Case File Number: VMD12-072 July 11, 2012

Location	5000 Piedmont Avenue (APN:048A-7002-603-02)
	To construct a two-story, 10,930 square foot funeral home to include memorial services, mortuary functions and associated offices at the existing Mountain View Cemetery.
Applicant/Contact Person: Phone Number:	David Trachtenberg, David Trachtenberg Architects (510)649-1414
Owner/Contact:	Mountain View Cemetery, Jeff Lindeman
Case File Number:	VMD12-072
	Major Variance to operate an undertaking service activity in a residential zone; and Regular Design Review for construction of a new structure.
	Urban Open Space
	RD-1 Detached Unit Residential Zone
	Exempt, Section 15332 of the State CEQA Guidelines: In-Fill Development Projects; Section 15183 of the State CEQA Guidelines: Projects consistent with a Community Plan, General Plan or Zoning. Section 15064.5 (b)(3) of the State CEQA Guidelines: Determining the Significance of Impacts on Historical and Unique Archeological Resources. Projects that follow the Secretary of the Interior's Standards for the Treatment of Historic Properties.

CITY OF OAKLAND PLANNING COMMISSION

Case File: VMD12-072

Figure 1: Immediate Setting of Proposed New Construction Mountain View Cemetery, Oakland, CA

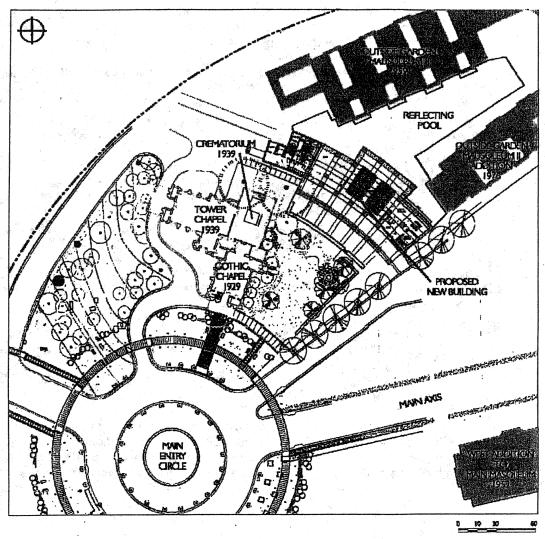
Immediate Setting [See Figure 1]

- Most existing planting is retained, including two important trees to the northeast of the crematorium.
- The Entry court to the new building forms a side yard to the existing buildings; the proposed pedestrian approach follows the line of existing vehicle movement;

- The proposed new building is placed mostly within an existing connector road that is not a part of the Olmsted master plan.
- The reflecting pool to the northeast (not a defining characteristic of the District) now is bordered on two sides by the Outside Garden Mausoleum II designed in 1959 by Kitchen & Hunt, Architects (OGM II) and the Outside Garden Mausoleum II Addition of 1976. Though the Cemetery was surveyed in 1998 (when the OGM II was less than 50 years old), it is possible that OGM II could be considered a historic resource now. The proposed new building at least partially obscures views of the OGM complex from the Entry Circle. That said, the new building is designed to allow views of the water and of OGM II through proposed new construction.

Figure 2: Comparison of Olmsted Master Plan with Existing Conditions Mountain View Cemetery, Oakland, CA

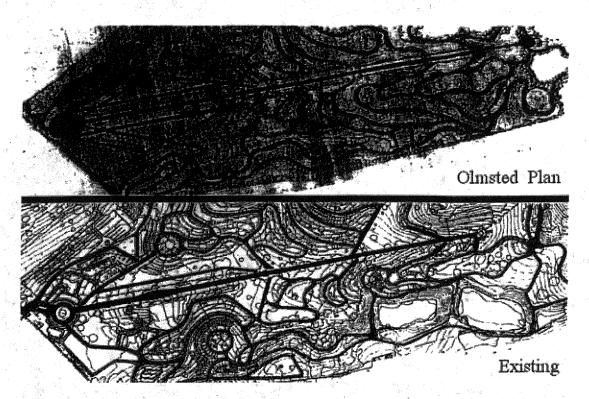
Olmsted Master Plan [See Figure 2]

- The key surviving aspects of the Olmsted Master Plan are: the entry circle, an important main axis (red in the illustration) running from the entry roughly east, a 'lozenge' of axial roads that define the first-encountered, more formal part of the Cemetery. Of this lozenge only a few axial roads were built, and even fewer survive; these are shown in dark blue on the Figure. Beyond the axial grouping, minor paths or ways follow existing topography (shown in light blue). A good many of these paths were built and do survive.

- The site of the proposed new building is not related to Olmsted's plan, and indeed is placed on a connector road (yellow in the illustration) that was last altered in 1959 as part of the development of Outside Garden Mausoleum II. If one were to choose a location, near the Entry Circle, that is least related to the Olmsted plan, this might be a good choice.
